CD Stereo Radio Recorder AZ8304

Service Information

AZ8300, AZ8301 and AZ8304 families

A93 - 188

FIGURE 1. OLD RCD-ID MECHANISM

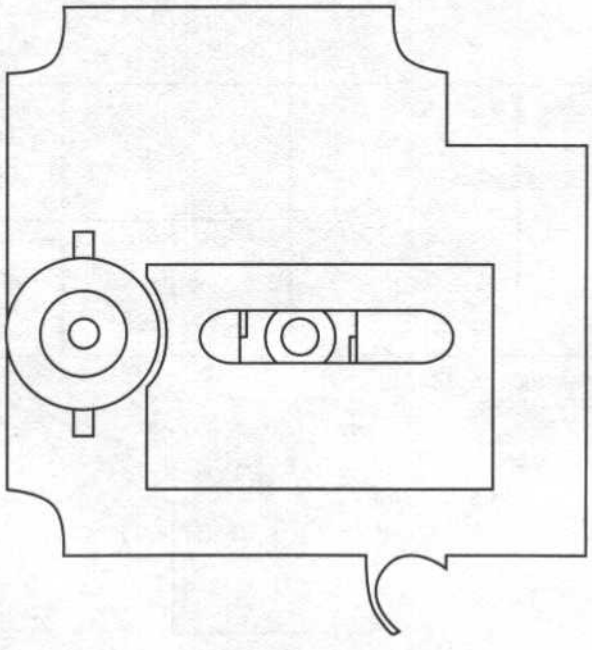
Due to **logistic problem** the RCD-1D mechanism will be available for limited stocks after which all defective RCD-1D mechanisms (see figure 1) must be replaced with RCD-1.2D mechanism.

For this reason the following are the **minimum necessary changes** required to adapt the electronics for use with RCD-1.2D mechanism:

Item	**From**	**To**	**Remarks**
2814	10µF	4.7µF	Focus search
2829	220µF	4.7µF	Vref buffer
3804	15k	8.2k	HF amplifier
3805	15k	8.2k	
3871	6.8k	18k	Sledge section
3872	100k	47k

After adaptations, electrical adjustments must be done according to the enclosed new adjustment table.
